CLARIFICATIONS FOR PROCUREMENT OF GOODS AND RELATED SERVICES ON THE AC TEST LABORATORY

RFP: 5610200-02/IFB/QCBS/01/20

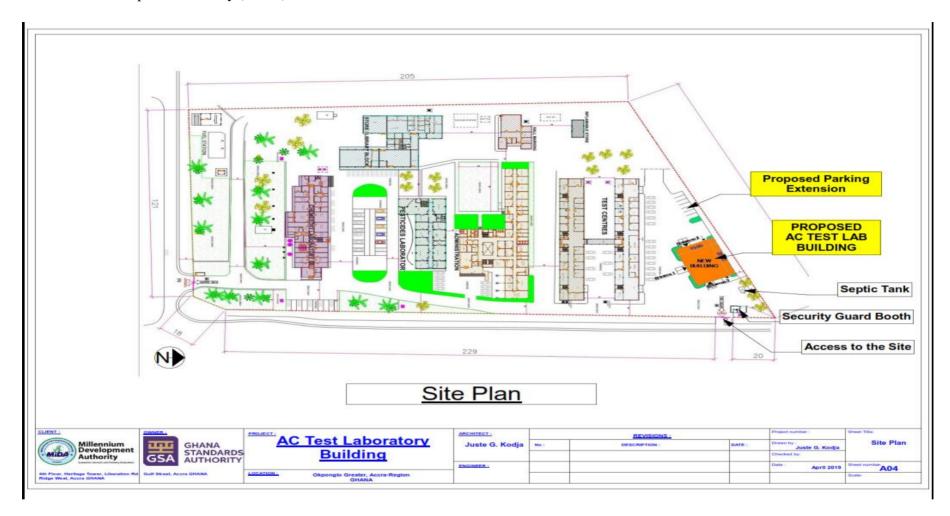
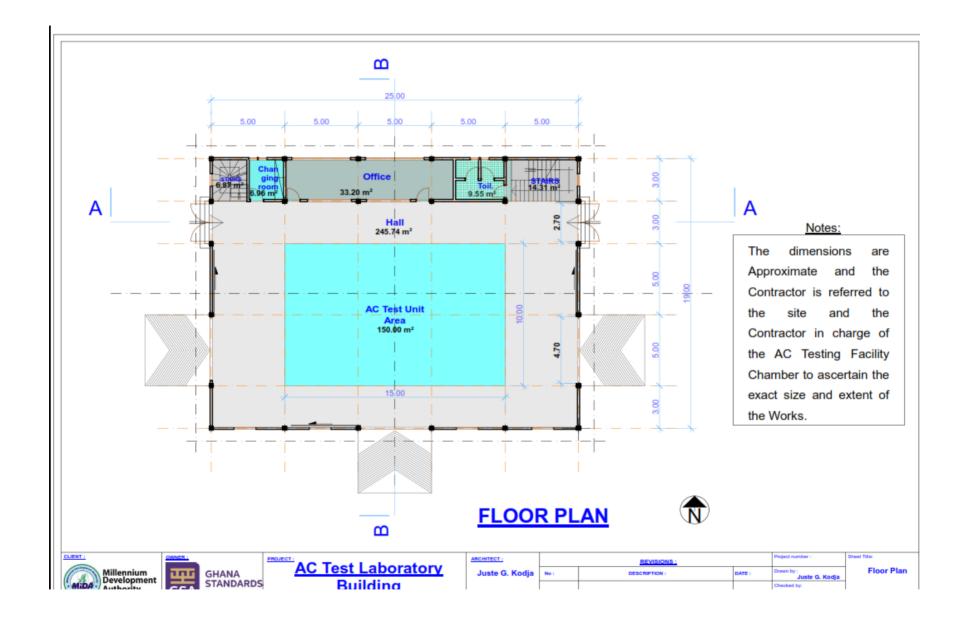
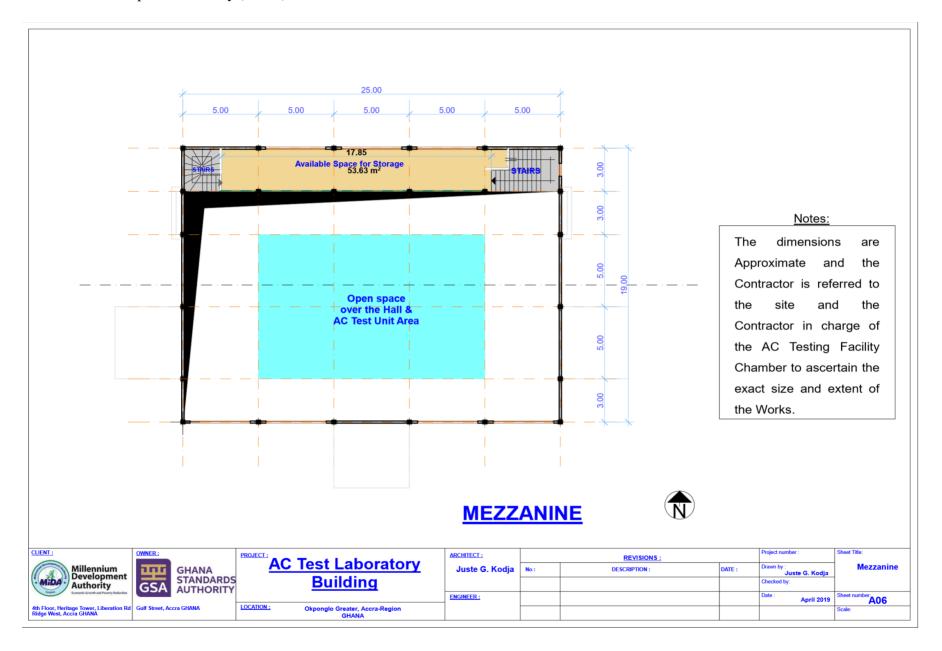
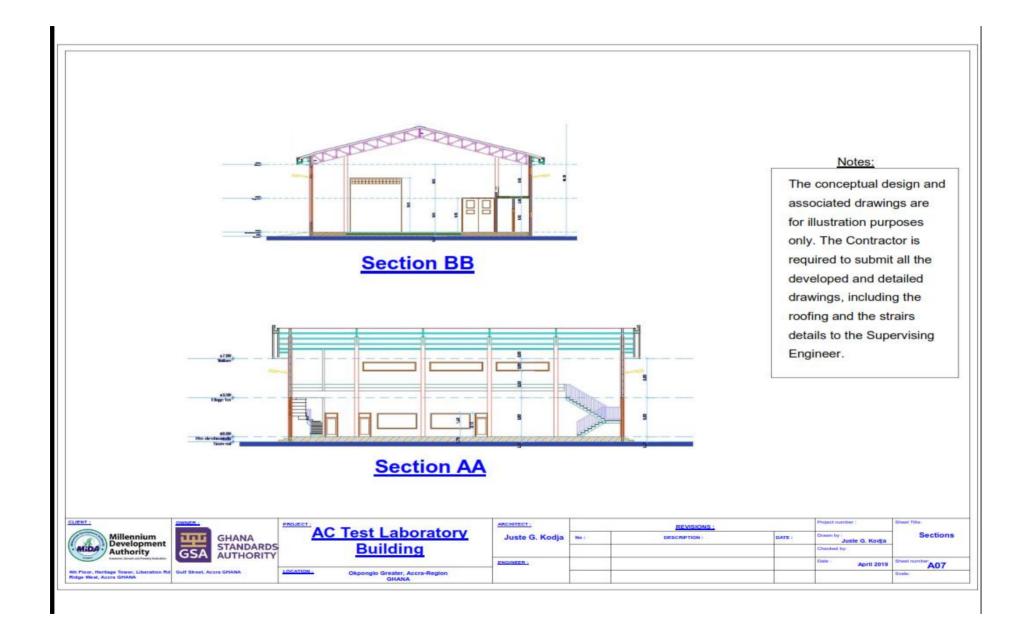
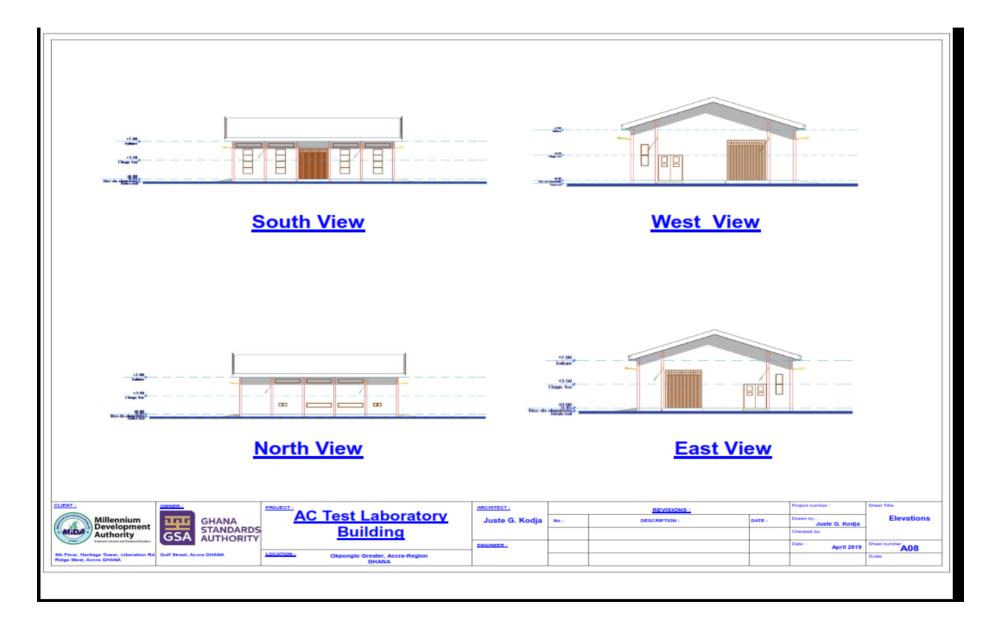
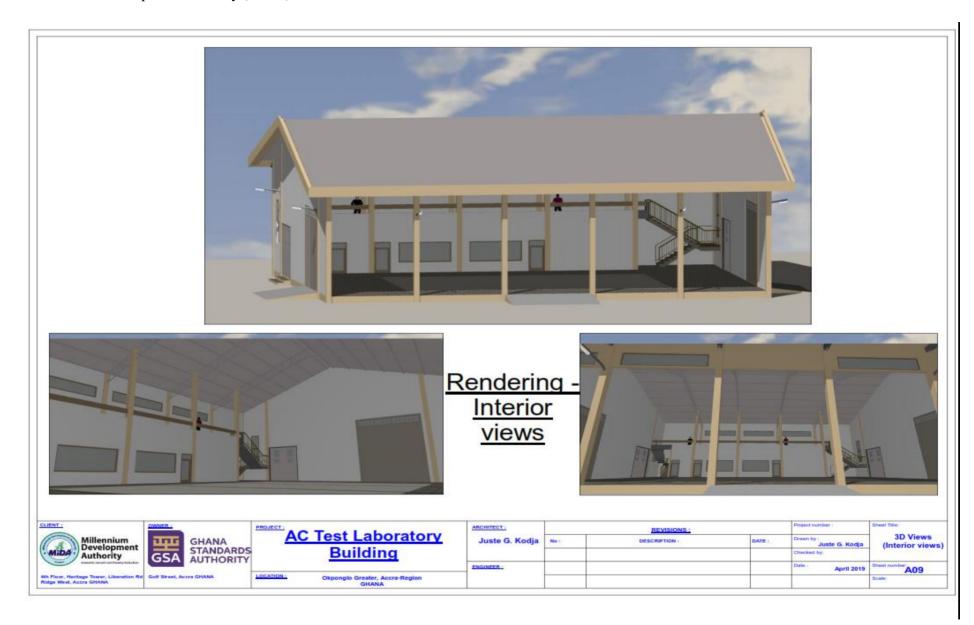
SI	Ref	Question	Answer
12	General	Please clarify clear height of the building in which the equipment will be installed	Please refer to the containment building blueprint attached.
13	General	Please clarify whether or not the test facilities will be installed in a pit in the floor so that the test chamber floors are level with the building and if not who's responsibility	Please refer to the containment building blueprint and provide comments as necessary.
14	General	If the equipment is not installed in a pit, please clarify who's responsibility it is to provide ramps, stairs, platforms, or other floor level needs in front of the chambers	Based on the containment building blueprint, the bidder is required to propose ramps, stairs, platforms, or other floor level needs for use with their proposed test chamber.
15	General	Please confirm that utility supply including but not limited to main facility power, chilled water, softened water, deionized water, city water, and compressed dry oil free air are the responsibility of the BUYER	Confirmed. Please refer to the containment building blueprint, and indicate the necessary requirements for main facility power, chilled water, softened water, deionized water, city water, and compressed dry oil free air, etc. appropriate for the system being proposed by the bidder.

18	General	Regarding the lab area, there're some requirements below that needs to be considered and factored into the civil works for the AC test laboratory. Please find attached the two layouts for details. a) Chamber size is 12000mm (L) x6000mm (W) x4500mm (H), Necessary surface is 14500mm (L) x9000mm (W).	Please refer to the containment building blueprint and provide comments as needed.

SI	Ref	Question	Answer
19			Please refer to the containment building blueprint and provide comments/requirements for the proposed test chamber as appropriate.
			Please refer to the containment building blueprint and provide comments/requirements for the proposed test chamber as appropriate.
20			Please refer to the containment building blueprint and provide comments/requirements for the proposed test chamber as appropriate.
21		b) Should dig a hole with drainage device of dimension : 12000mm (L) ×6000mm (W) ×700mm (deep) . And the height of place is ≥4200mm. Please does the available space dedicated for the installation of the AC test laboratory meet the	Please refer to the containment building blueprint and provide comments/requirements for the proposed test chamber as appropriate.
